Subject: Murex Autolynx 4i MIG Welder

Number: 180

SERVICE BULLETIN

MUREX Autolynx 4i Inverter MIG Composite

Autolynx 4i Schematic Diagram 1.02.2002 (ver.2)

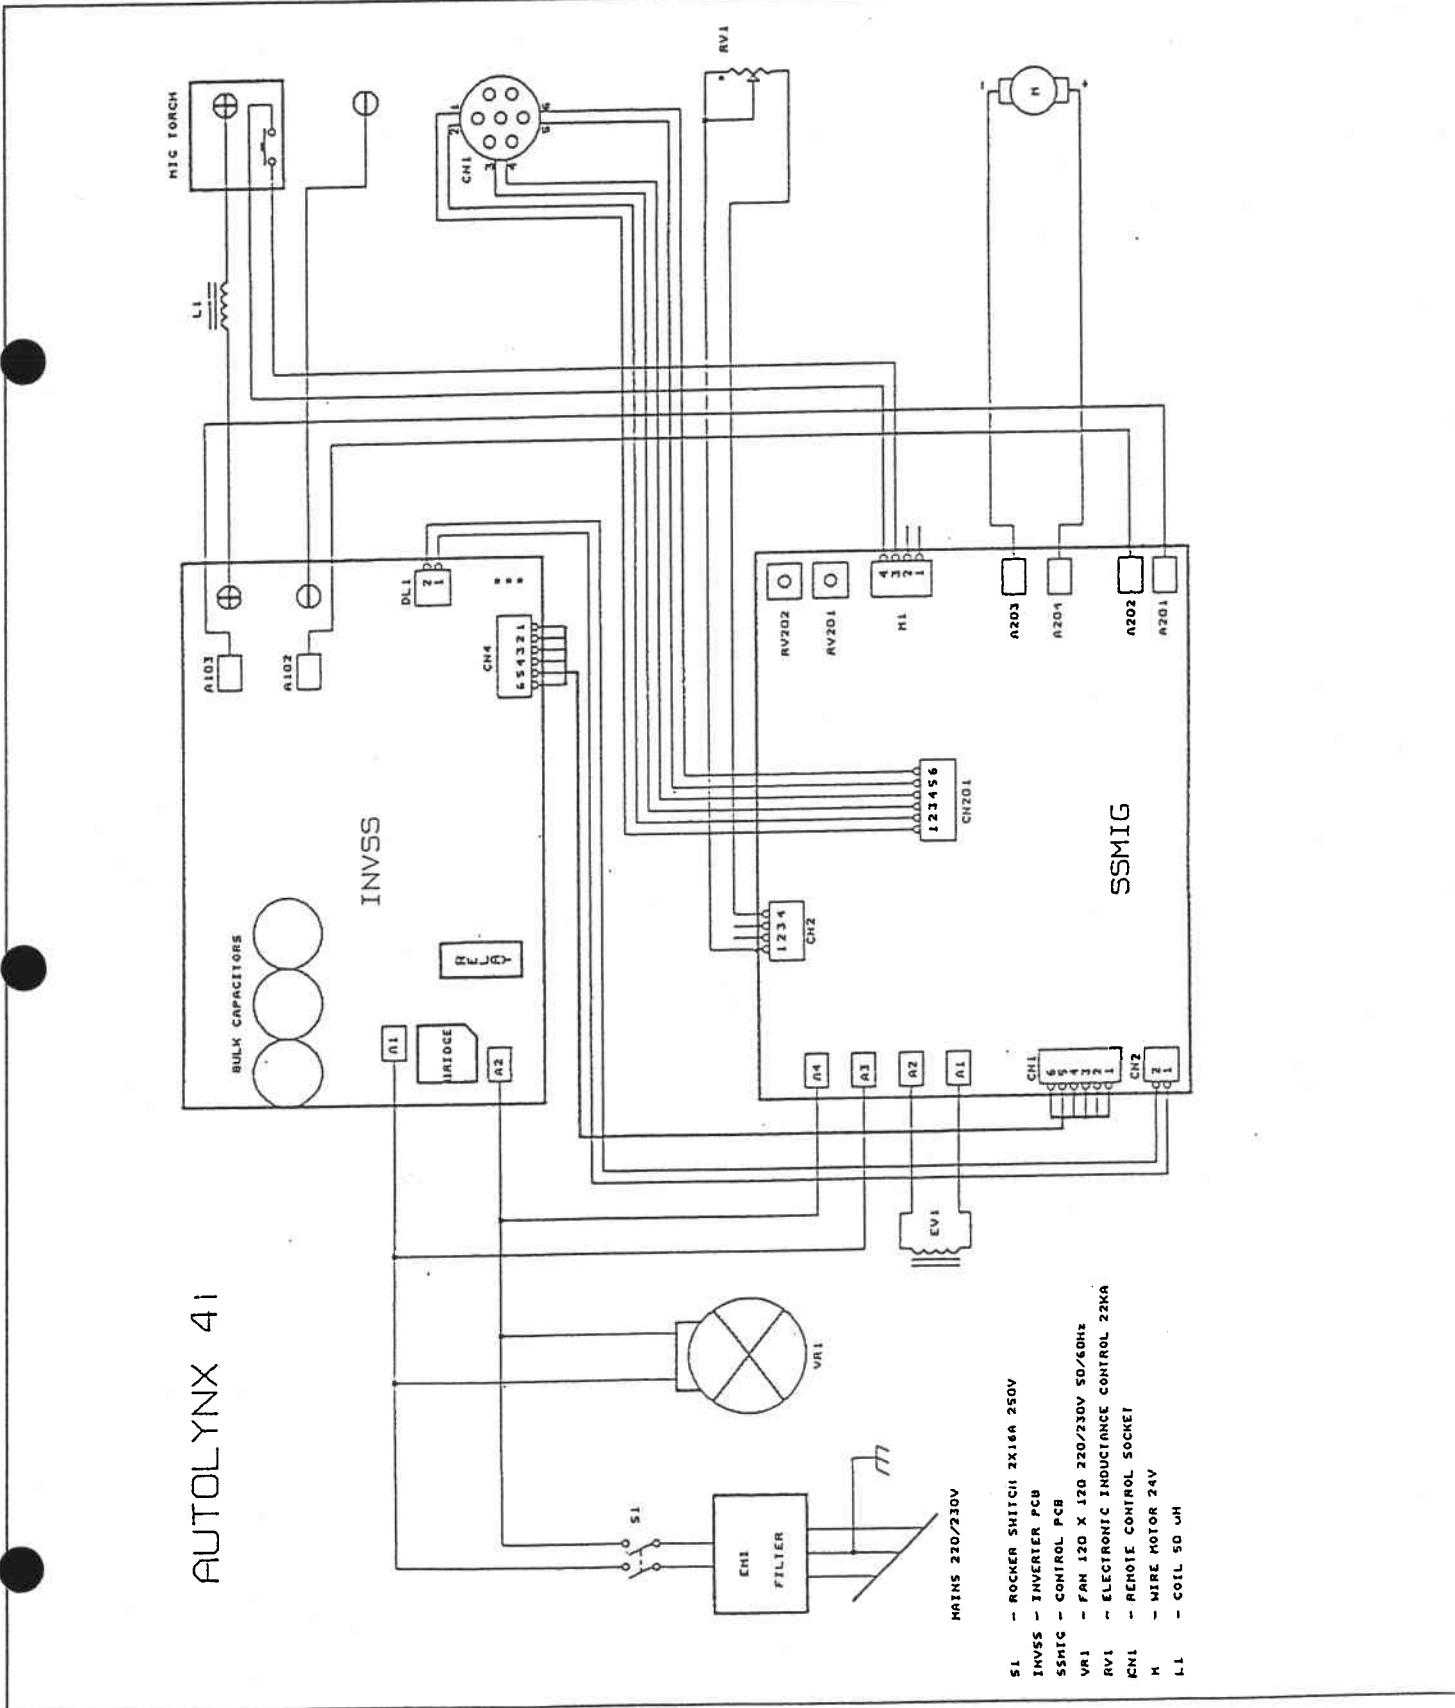
PLEASE DESTROY ANY PREVIOUS VERSION (14/05/01) OF THIS DOCUMENT AS IT CONTAINS AN ERROR IN THE SCHEMATIC DIAGRAM. THE CONNECTIONS BETWEEN THE (OCV) OUTPUT OF THE MAIN INV PCB AND THE CONTROL PCB (A102, A103/A201, A202) ARE SHOWN REVERSED, LIKE THIS THE MIG CONTROL PCB WILL FAIL – IC U2 ON IT (40106) WILL BE DAMAGED RESULTING IN NO RESPONSE TO THE TORCH SWITCH

!!!ORIGINALLY SHOWN
REVERSED!!!

| 2. | Schematic Diagram | ver.2!!! |
